Cabinet

Report Title:	Response to EDF Energy's Sizewell C Stage 4 Public Consultation		
Meeting Date:	24 September 2019		
Lead Councillor(s):	Cllr Richard Smith MVO, Cabinet Member for Finance and Assets and Lead Cabinet Member for Sizewell C		
	All Councillors, but in particular		
	Aldeburgh and Leiston – Councillor Russ Rainger		
Local Councillor(s):	Blything – Councillor Richard Smith MVO		
	Carlford - Councillor Robin Vickery		
	Felixstowe North and Trimley – Councillor Stuart Bird		
	Framlingham – Councillor Stephen Burroughes		
	Martlesham – Councillor Patricia O'Brien		
	Wickham – Councillor Alexander Nicoll		
	Wilford – Councillor Andrew Reid		
	Woodbridge – Councillor Caroline Page		
Director:	Mark Ash, Director of Growth, Highways and Infrastructure		
Assistant Director or Head of Service:	Bryn Griffiths, Assistant Director, Infrastructure & Waste		
Author:	Michael Moll, Programme Director Sizewell C

Table 1: Comparison of mitigation measures of rail-led, integrated and road-led freight management strategies (Table from the Stage 4 consultation document)

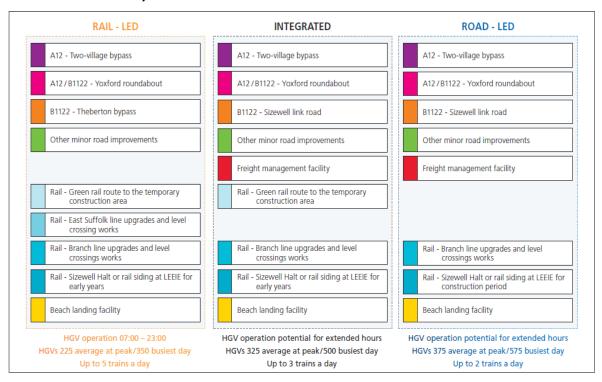
- 64. From the representations of local communities we have seen from the Stage 3 consultation, there was little local support for the road-led strategy. It was not supported by the Councils in our Stage 3 response. The integrated strategy does represent a limited increase in the use of the rail network and some decrease in HGV movements. The integrated strategy takes on all road mitigation schemes from the road-led option (i.e. Sizewell Link Road, Two Village Bypass, Yoxford Roundabout, Freight Management Facility), and combines these with a direct rail route into the temporary construction area from the rail-led option. Table 1 shows the difference in mitigation between the three options.

65. The integrated strategy would provide three rail deliveries (six rail movements) over a 24-hour period – one more than the road-led option but two less than the rail-led option. It is important to note that of these six rail movements, five are during the night between the last and first passenger trains on the East Suffolk line, i.e. between 11pm and 6am. This is unlike the rail-led strategy where all rail deliveries are expected to occur during daytime (except for during the early years). The noise and vibration impact of these night-time movements on residents along the East Suffolk Line and Sizewell Branch line should not be underestimated. It should be noted that for the road-led and integrated options, trains would operate at a speed of 20mph, whereas with the rail improvements
